## State Water Resources Control Board

November 19, 2021

### ***KINGS GROUNDWATER SUSTAINABILITY PLANS, GROUNDWATER SUBBASIN NO. 5-022.08***

### Appendix – Select constituents in Kings Subbasin wells

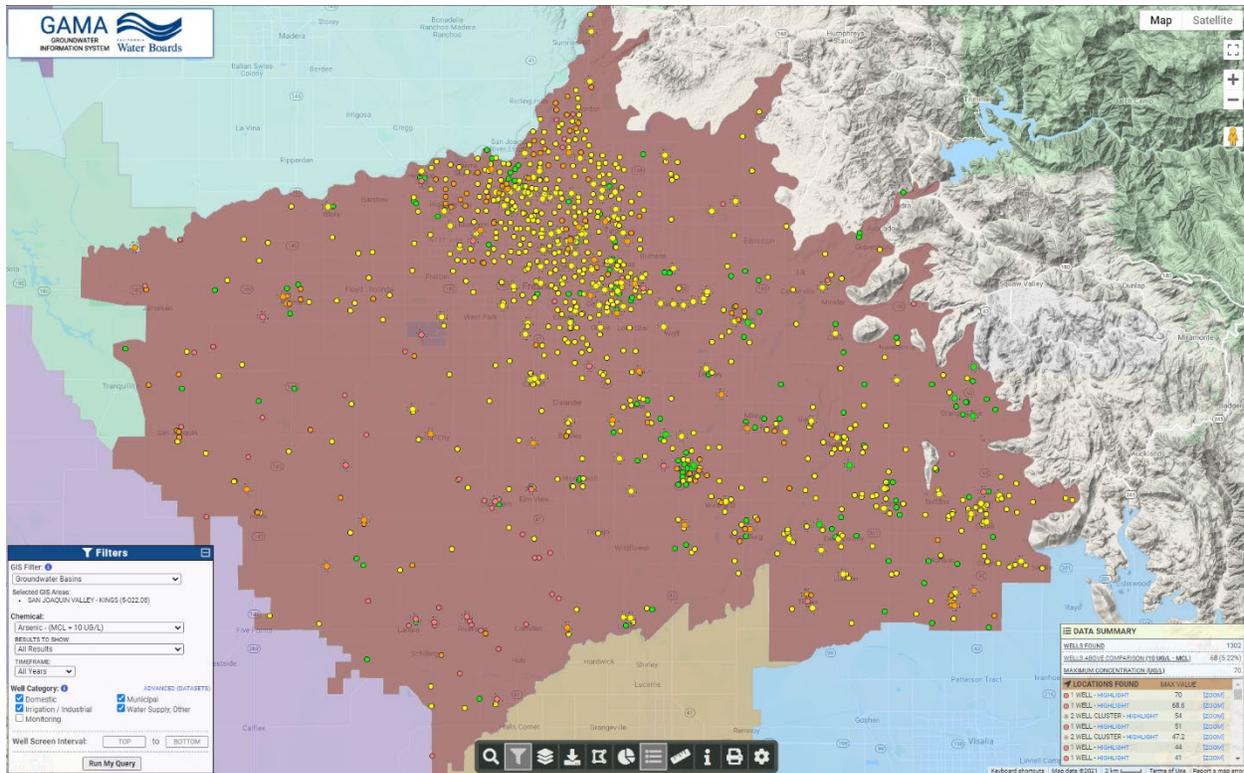
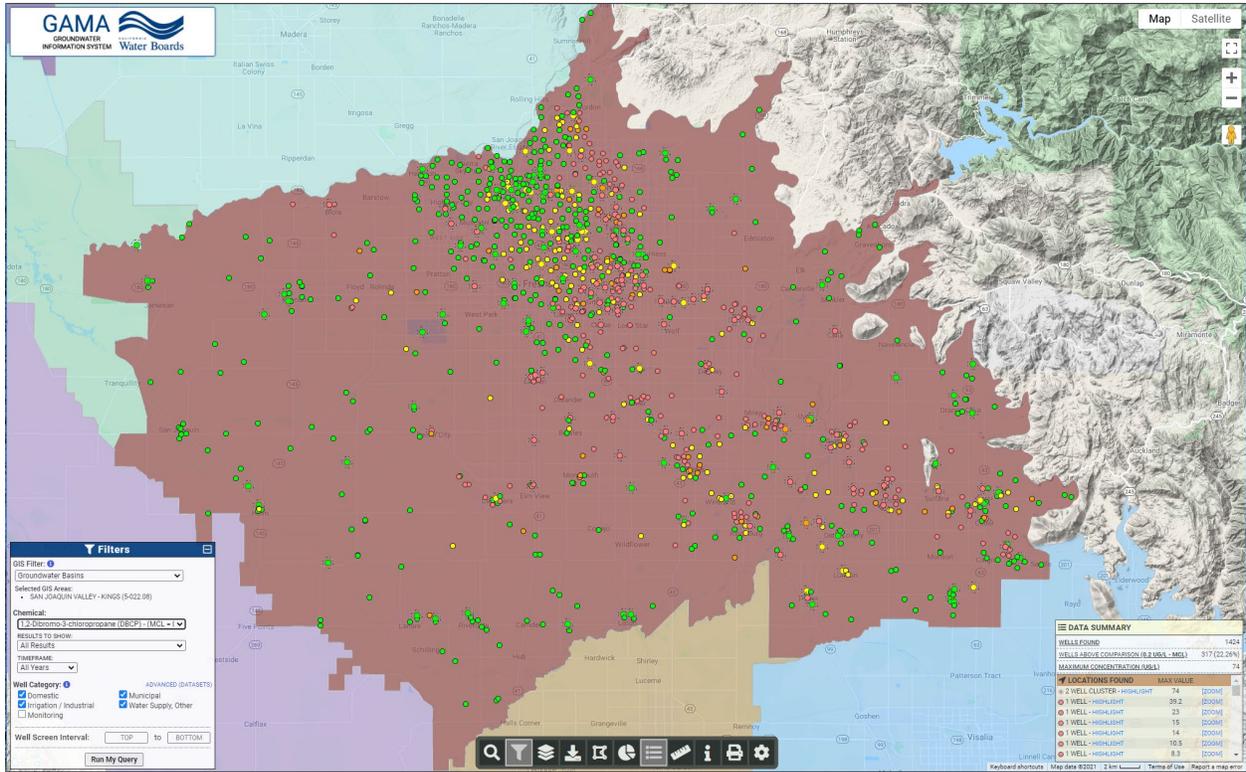
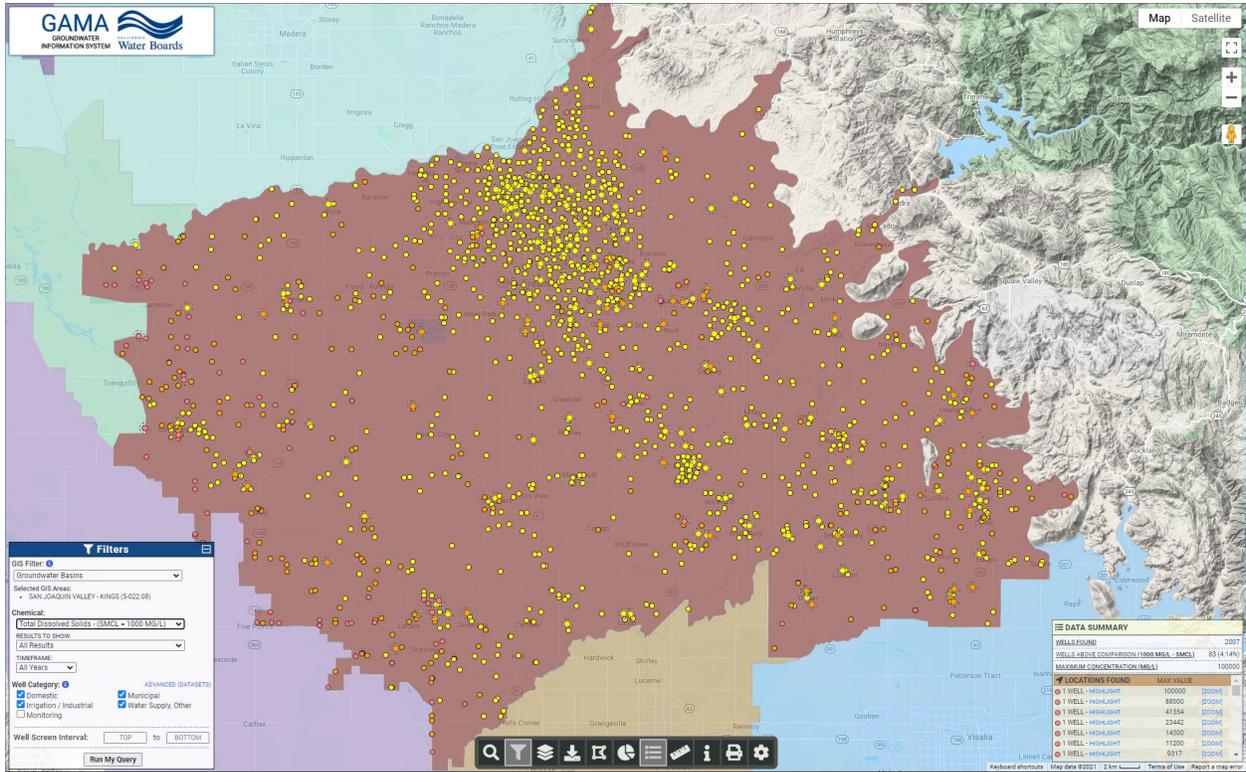
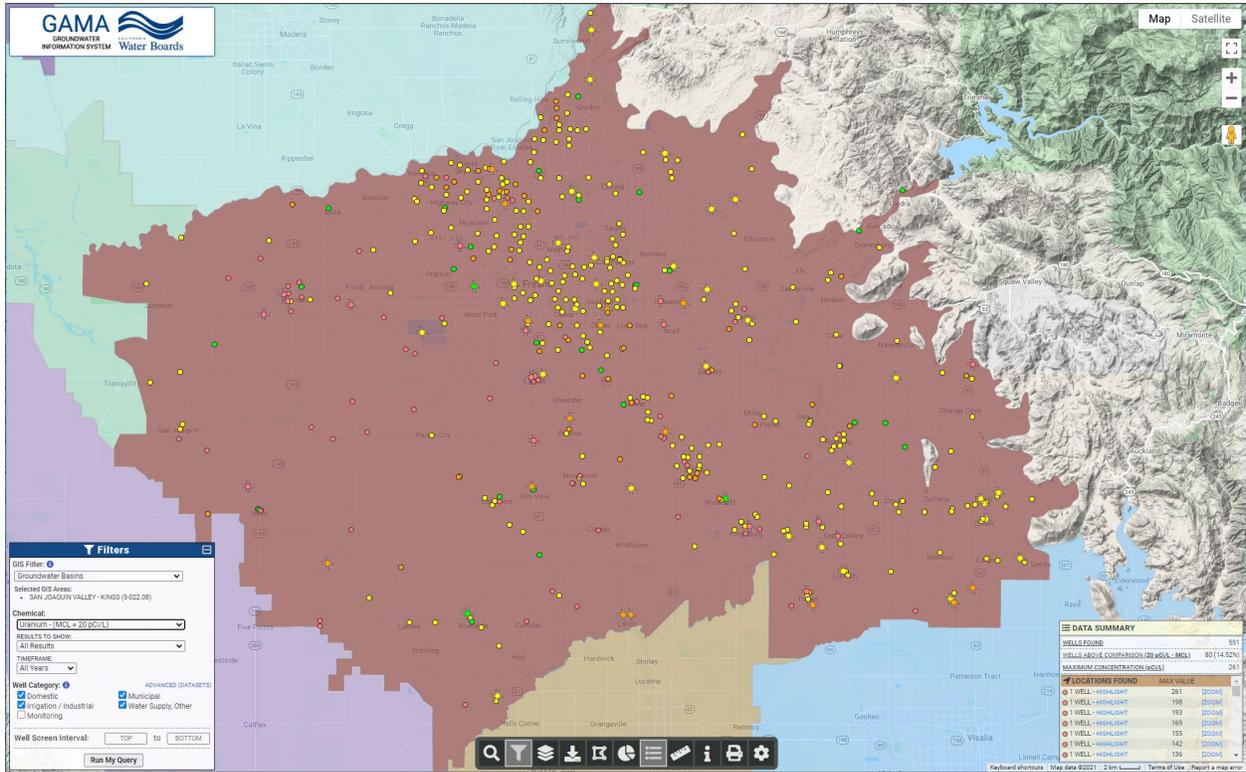
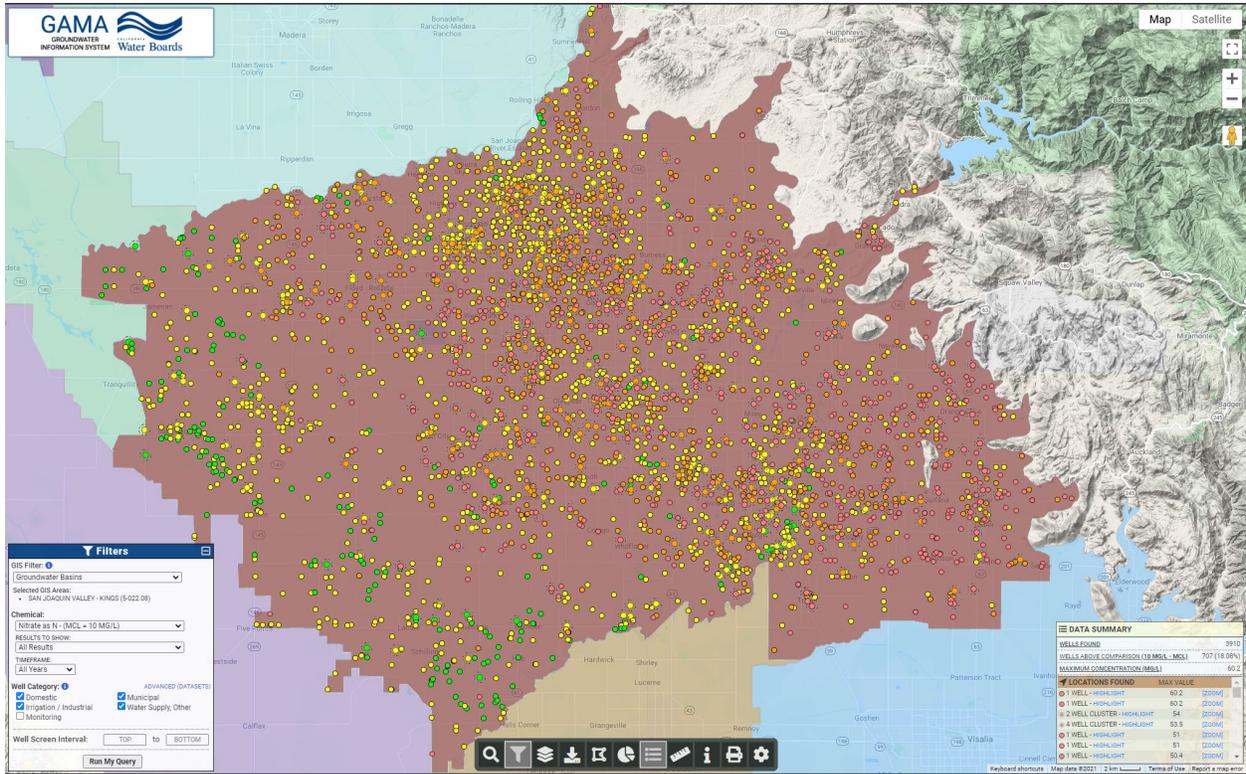
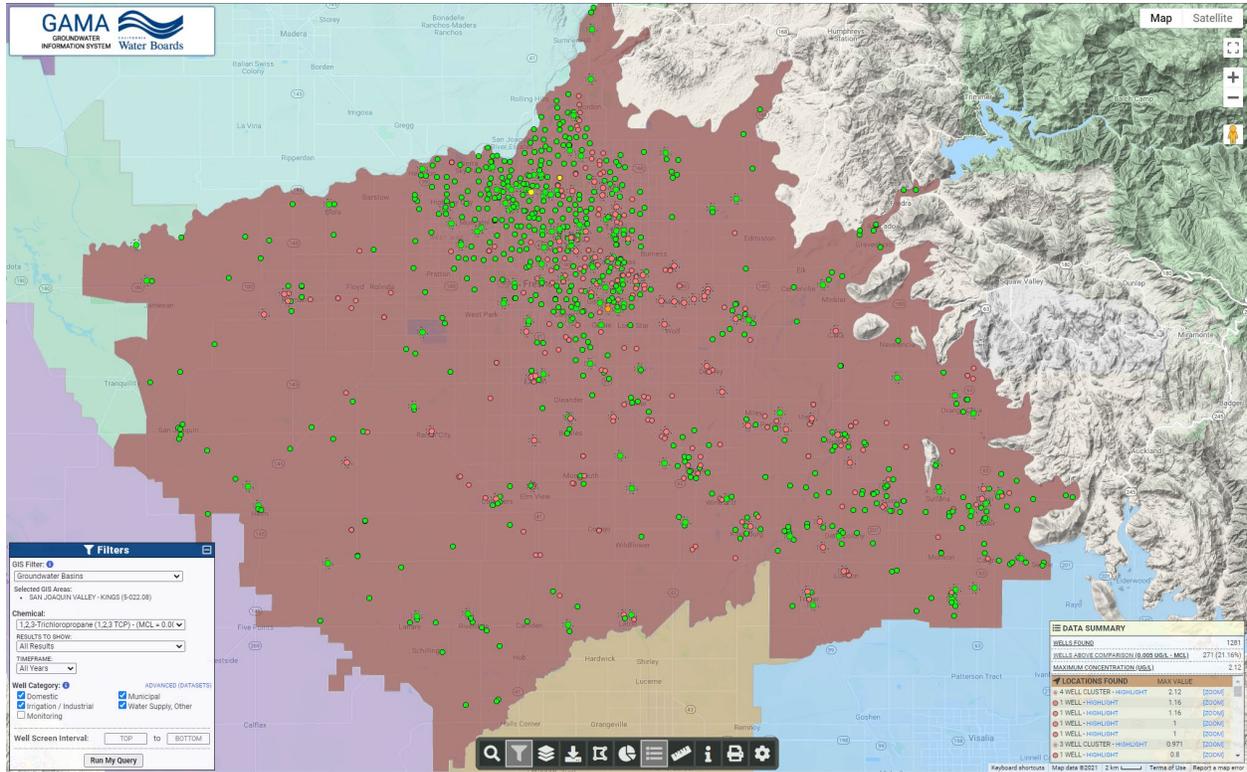
Staff recommends the GSAs coordinate to define undesirable results consistently for the subbasin, manage for the same set of constituents in SMC, and have coordinated monitoring well locations and sampling frequencies. Based on their prevalence within the subbasin, all of the GSAs should include, at minimum, SMC for TDS, arsenic, nitrate, uranium, DBCP, and 1,2,3-TCP.

Staff has attached maps from the [State Water Board Groundwater Ambient Monitoring and Assessment \(GAMA\) Program's database](https://gamagroundwater.waterboards.ca.gov/) (<https://gamagroundwater.waterboards.ca.gov/>) showing TDS, arsenic, nitrate, uranium, DBCP, and 1,2,3-TCP impacts in subbasin groundwater (Figures 1 through 6 in Appendix).
